Memorandum Department of Planning

RE: 18122 Chesterfield Airport Rd. (Scott Properties) ASDP: An Amended Site Development Plan and Amended Architectural Elevations located on a 12-acre tract of land located north of Edison Avenue, east of Spirit of St. Louis Blvd, south of Chesterfield Airport Road, and west of Crown Industrial Ct, zoned "M3" Planned Industrial.

Planning Commission Staff Report

Description: 18122 Chesterfield Airport Rd. (Scott Properties) ASDP: An Amended Site Development Plan and Amended Architectural Elevations located on a 12-acre tract of land located north of Edison Avenue, east of Spirit of St. Louis Blvd, south of Chesterfield Airport Road, and west of Crown Industrial Ct, zoned "M3" Planned Industrial.

3 BUILDING 4 - EAST ELEVATION
3/32" = 1'-0"

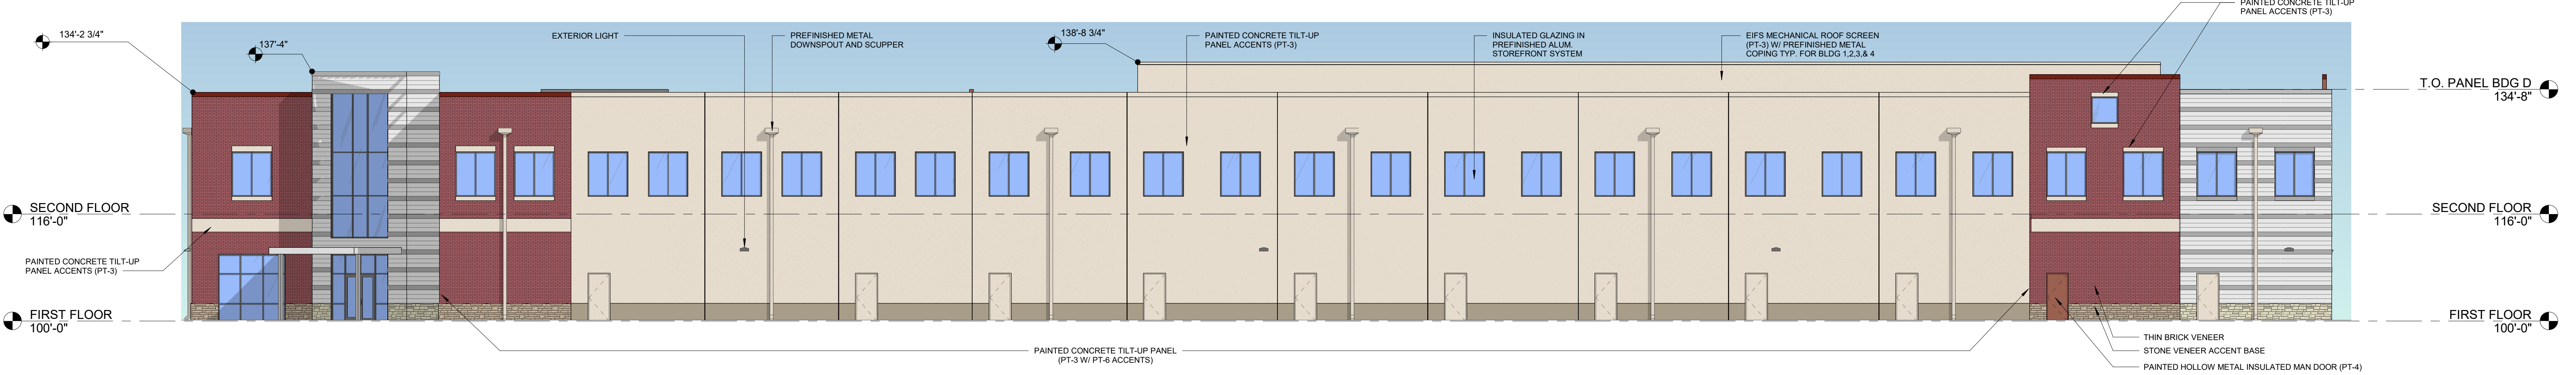
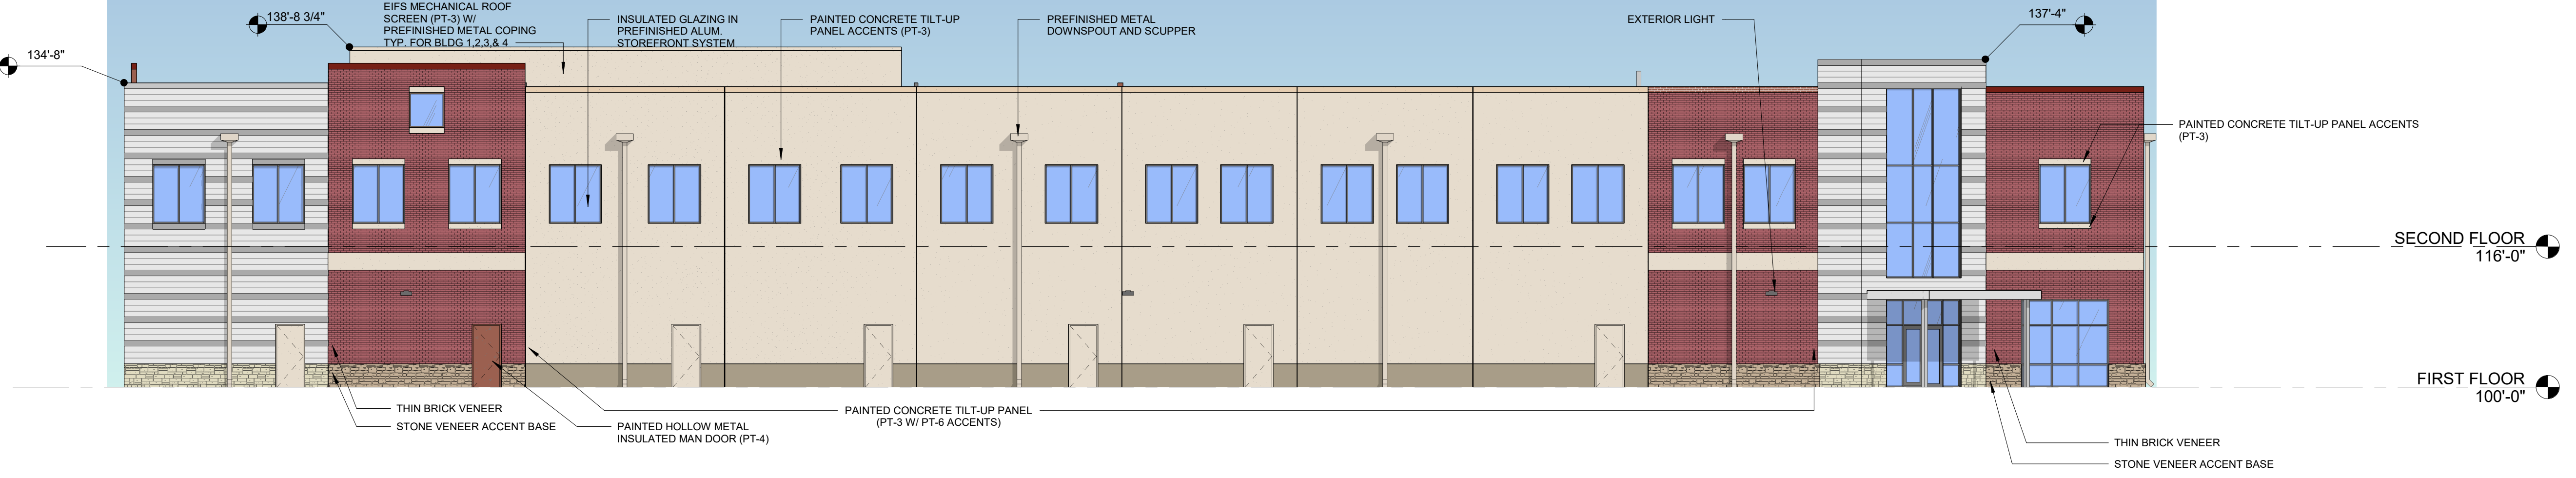
- The proposed common brick to be wrapped around the southeastern inset of the south and east facades to a logical break of Building 4.

The submittal has since been revised to meet the condition made by Architectural Review Board.
